ATTACHMENT 2

The following information are provided per Attachment I dated 10/28/2021.

EPA Request #1:

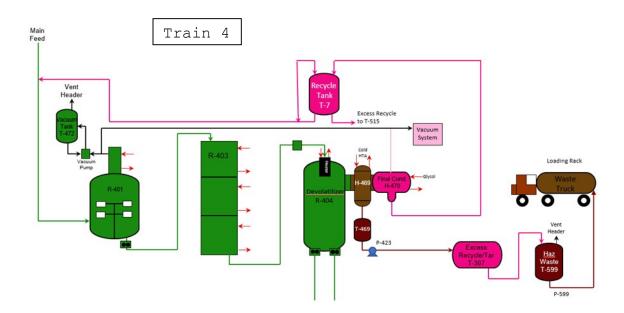
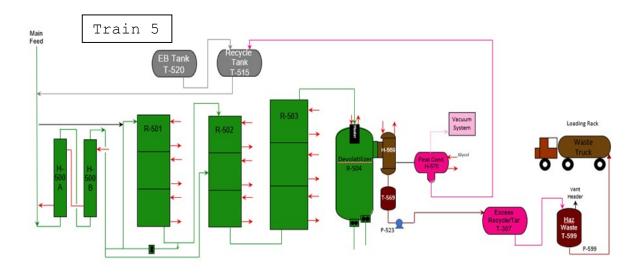
1. On September 2, 2021, AmSty responded to an EPA August 20, 2021, e-mail request for information regarding vessels T469 and T569. The information provided is not sufficient to understand how the partial condenser and condenser function, what materials from the manufacturing process are being recycled, and exactly how the waste sent to the hazardous waste accumulation tank, T307, is generated. EPA requests AmSty to provide a written description and supporting figures which helps EPA better understand how each type of condenser functions. Note: If this information will be classified by AmSty as Confidential Business Information, the information should be submitted to EPA via EPA's online secure file transfer service.

The AmSty polystyrene production process starts with styrene monomer feeding into series of reactors to convert styrene to polystyrene polymer by thermal and chemical reactions. The polystyrene (PS) polymer stream then goes through a heat exchanger and into the vacuum Devolatizer to flash off the unconverted materials (styrene, ethylbenzene, and tars which is mainly dimers, trimers, and oligomers).

The flash-off materials from the Devolatizer are recovered through a condenser system which contains a partial condenser (H-469/H-569), a final condenser (H-470/H-570), and a knockout tank T-469/T-569 (see above flowcharts). Vapors travel through a spool piece from the Devolatilizer (R-404/R-504) to the partial condenser, H-469/H-569. Cool heat transfer fluid is circulating through the tube side of the heat exchanger to condense the heavier components (mostly dimers, trimers, and oligomers) from the vapor stream. The heavier components, or tars, then drop into a knockout tank, T-469/T-569. The remaining vapors continue on to the chilled glycol cooled final condenser (H-470/H-570). This final condenser liquefies styrene and ethyl benzene vapor which is then pumped into the recycle storage tanks (T-7/T-515) and fed back to process. All of the above listed equipment are part of the manufacturing processing unit to produce the final polystyrene product. T-469 and T-569 are included in the AQMD Train 4 and Train 5 Permit To Operate as equipment required for the "Polystyrene Resin Manufacturing System". Attachment "G30184 Train 5 Polystyrene Manufacturing System" is included.

T-469 and T-569 are a part of the condensing system for a few specific reasons. First is the requirement to have an area for the condensed liquid to accumulate. If the liquid started accumulating in the condenser itself, then the capacity and effectiveness of the condenser decreases. Secondly the liquid level in T-469 and T-569 provides a seal between the vacuum part of the condensing system and the slightly above atmospheric pressure in T-307 and T-599 to prevent vapors entering the condenser. Third, a liquid level in T-469 and T-599 helps reduce the possibility of cavitation leading to failure of a pump and air entering the condenser. Therefore, the level in the tank is kept between 24% - 35% pumping a few times a day to avoid overfilling and running empty.

Vapor leakage into the system is undesired for many reasons including optimizing the partial and final condenser capacity, product property performance, and most importantly to avoid a decrease in the vacuum leading to a failure of flashing the styrene and ethyl benzene. If enough vacuum is lost, it results in an immediate SIS trip of the unit operation for process safety concerns.
